D-3 COMMENT AND RESPONSE REPORT

PROPOSED REZONING, SUBDIVISION AND DEVELOPMENT OF HAASENDAL ESTATE ON ERVEN 23582, 23583, 23584, 23579 & 23580 (REGISTERED AS ERF 23324), IN KUILS RIVER, WESTERN CAPE.

Tygerberg District Spatial Development Plan (2012) - site within the circled area

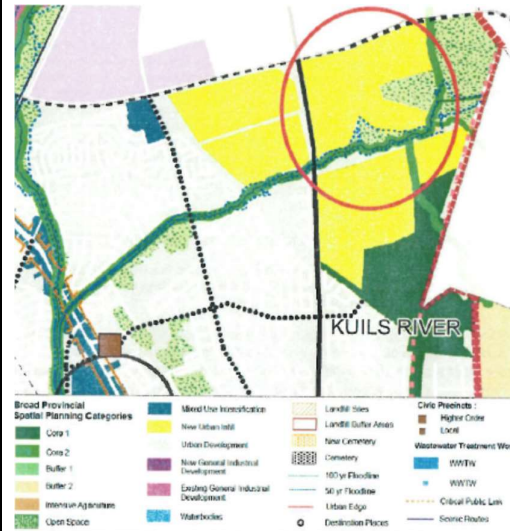
<p>Open spaces systems and ecological corridors</p> <p>The proposed open spaces align with the wetlands and river corridor buffer zones adequately so as not to negatively affect them, and to ensure their conservation, use and enjoyment. However, we are concerned that not all residents will have access to the public open space (zoned Open Space 2) amenities. In this regard, the retention pond / reservoir to the north, must be zoned OS2, rather than Special open space (OS3) - which could enable an owner to prohibit public access in the future. It is important that the entire wetlands and riverine corridors which have public routes traversing them, remain in public ownership in perpetuity so as to safeguard public access to these natural environmental resources.</p>	<p>As per the latest Subdivision Plan (HDAmphoria_Sub18 dated 14 October 2019) the proposed development incorporates 82163m² (19, 20 & 40) for Bottelary River Park (public), 18120m² (10) for Haasendal Park (private) and 41946m² (21 & 41) for School Fields that will be open to the public.</p> <p>Most of the public open space is structured around the Bottelary River. Additional 946m² (3) and 1564m² (42) strips of land to the north and south have been incorporated to serve as access opportunities. The strip to the north will provide access to Haasendal Park for the Turnberry development. Turnberry has no internal private space and will therefore need access to the planned estate park. The Links, located on Erf 23325, will have their own private courtyard. Access will therefore not be granted to The Links. However, they will have access to the Bottelary River Park as well as the school fields that will be open to the public.</p> <p>The developer has already decreased the security section of Haasendal Estate dramatically to ensure that most of Bottelary River will be open to the public.</p>

<p>The proposed development aligns with the City's <u>Tygerberg District Spatial Development Plan</u> - see excerpt below. The proposed development also aligns with the City's Floodplain and River Corridor management</p>	 <p><u>Old Security Section vs New Security Section</u></p> <p>A private road will be required to serve the security section of Haasendal Estate. It is imperative to the successful functioning of the access controlled portion of Haasendal Estate, as a secure and access controlled environment, that the Haasendal Park private open space be fenced and that access can be controlled via biometric technology. If Haasendal Park cannot be an access controlled open space it will negate all the security planning for this portion of the development. This is not acceptable to the developer as the secure, access controlled portion of the Haasendal Estate is an important product aimed at a specific market segment envisaged in this mixed use estate.</p> <p>This is noted and agreed.</p>

Policy (2009) whereby development is set back outside the 1:100 and 1:50 year floodplains.
